**NHTSA#** Jayco 18V-292  
Starcraft 18V-294

**Recall  
Remedy**

### INSTRUCTIONS – Installation of the Stop Plate – ONLY 2011-2013 Camping Trailers manufactured prior to OCTOBER 2012 with a Power Roof Lift System.

End Piece

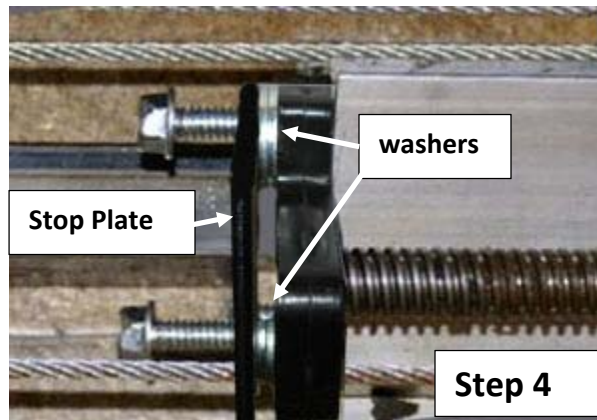
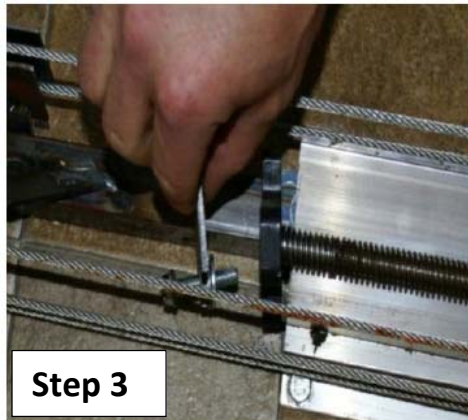
2. Once you have gained access, locate the lifter system actuator (end piece) **(Fig 1A)**

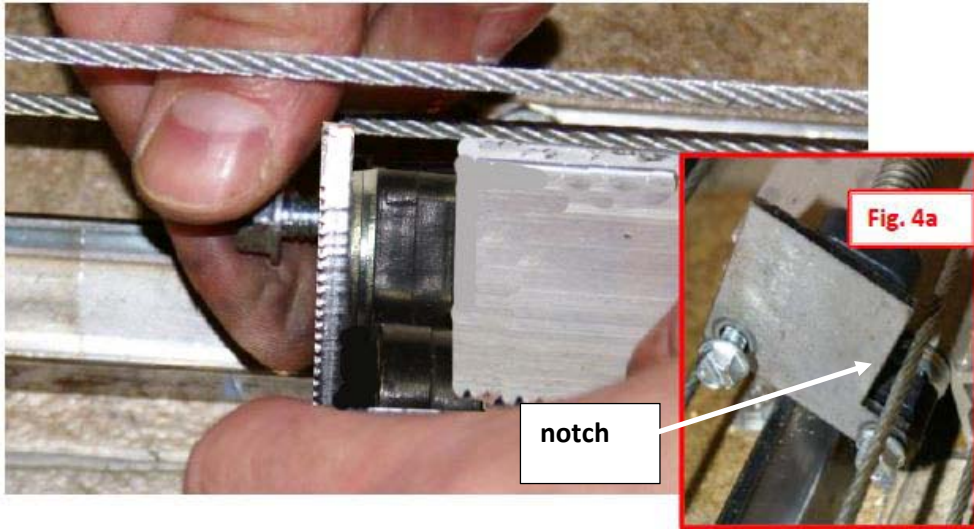
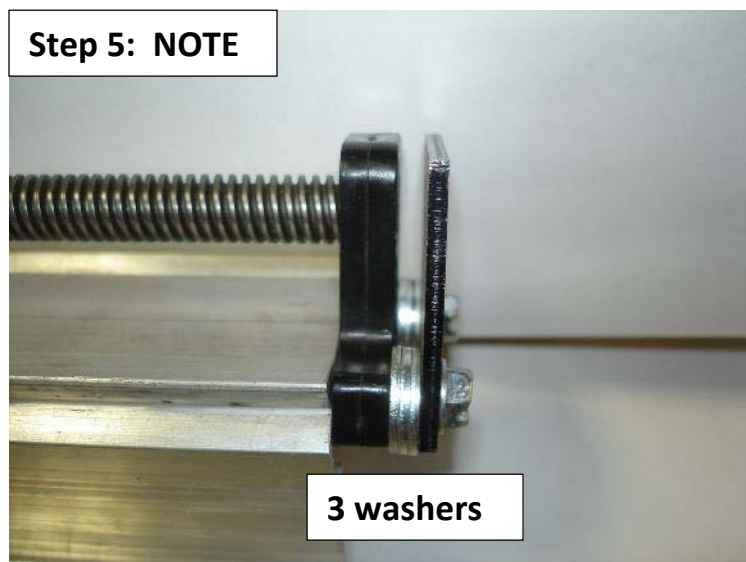
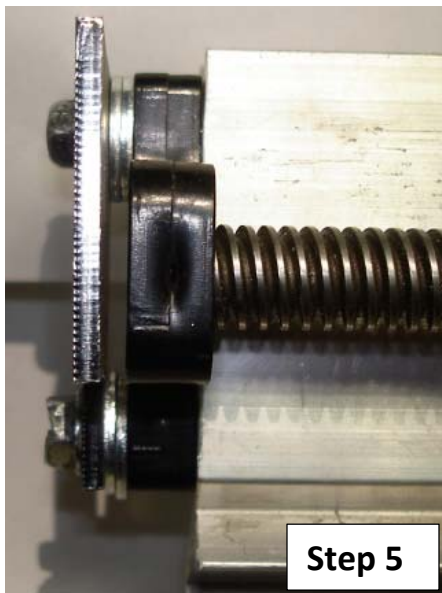
3. Using the 3/8" socket (or nut driver), remove the 2 screws holding the actuator to the aluminum extrusion.  
Remove the black plastic end piece.
4. Insert one of the screws through the hole in the stop plate, add 2 washers, then insert the screw through the hole in the end piece and install the screw into the aluminum extrusion. Insert the second screw through the other hole in the stop plate, add 2 washers, insert the screw through the hole in the end piece and install the screw into the aluminum extrusion. The end piece should be butted against the aluminum extrusion. Washers should be between the end piece and the stop plate.

**NOTE:** Looking at the stop plate, the notch should be on the right side so the stop plate does not restrict or touch the cable.

**NOTE:** Validate that if the threaded rod protrudes out the back of the end piece (between the stop plate and the end piece) that it does not make contact with the stop plate. If it makes contact with the stop plate, then a third washer should be added to each screw. The threaded rod should be contained inside the black end piece and not make contact with the stop plate.

5. Tighten both screws making sure the screws are securely in place (cables not shown).

### Manual Over-Ride Warning

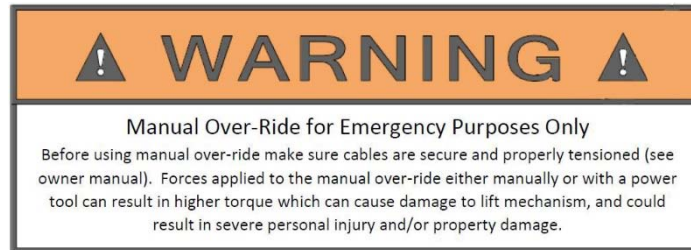
Installation of WARNING LABEL - required on ALL 2011-2015 affected camping trailers.

1. Using isopropyl alcohol and a clean shop rag, clean the area where the label will be applied.
2. Allow the area to dry for at least 30 seconds.
3. Remove the protective backing from the label.  
Apply the warning label underneath the tail light and to the right of the manual override access cover.  
Remove any air bubbles from the label.
